# CRITICAL INSTRUCTIONS

Application: Mercedes Sprinter

Part Number:  
10009880036/  
10009880036E  
10009880074/  
10009880074E

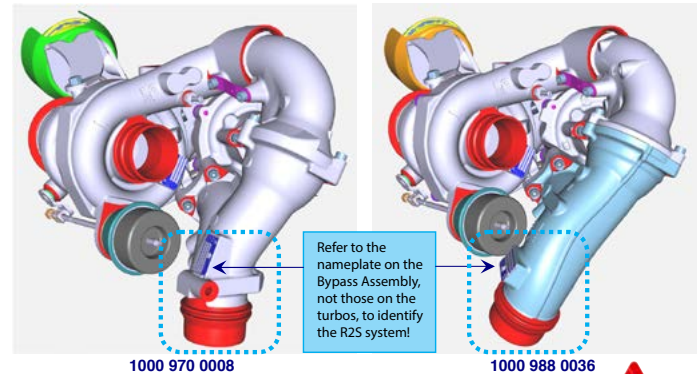
When replacing a 10009880008/10009880008E (In production between September 2008 and December 2010, fitted up to engine 30468350) with a 10009880036/10009880074, additional components are required which need to be sourced directly from the Main Dealer:

This is due to a geometrical difference between the two products and without the additional products, the replacement turbo will not be able to be fitted.

Charge air pipe A 906 528 5082 or -5182\*

Coolant pipe A 906 501 1482

Support A 651 096 2940

Support A 651 096 3040

Screw (3x) N 910143 006001

\*Use -5182 if vehicle has optional equipment codes H08, N63 or HK4
